HELLIER RESIDENCE POOL
710 Bedford Road
Town of North Castle
Westchester County, New York

TITLE: **SITE PLAN**

RE: Hellier Residence Swimming Pool RPRC Review
710 Bedford Road, Armonk
Town of North Castle
Section 95.03, Block 1, Lot 2

RPRC RETURN LETTER

Dwg. No.: **C-101**

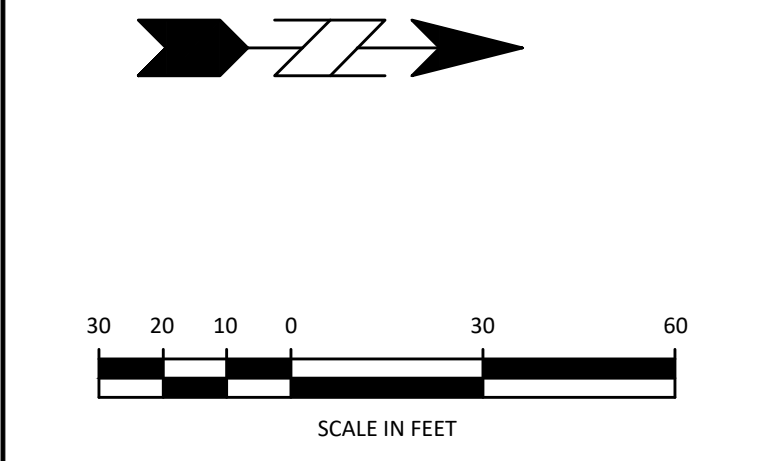
- 3. Provide stormwater mitigation design calculations for the runoff generated by the net increase in impervious surface for the 25-year, 24-hour design storm event or a six (6) inch pool drawdown volume; whichever is greater. Provide details of the stormwater mitigation system.*

- 4. The plan shall include the proposed stormwater collection and piping system. Provide rims, inverts, size and material for all drainage facilities. Provide details.*

- 5. The plan shall include emergency overflow for the infiltration system to a stabilized outfall. Please direct the discharge to a location which will not discharge onto the neighboring property.*

Response: Stormwater mitigation design calculations for the runoff generated from the proposed impervious surface has been prepared and is attached for your review.

Response: Plans have been updated to include the proposed stormwater collection, piping and details of the drainage system.

Response: An emergency overflow for the proposed infiltration system has been provided. A rip rap dissipator is proposed at the overflow outlet. Overflow will not discharge onto the neighboring property.
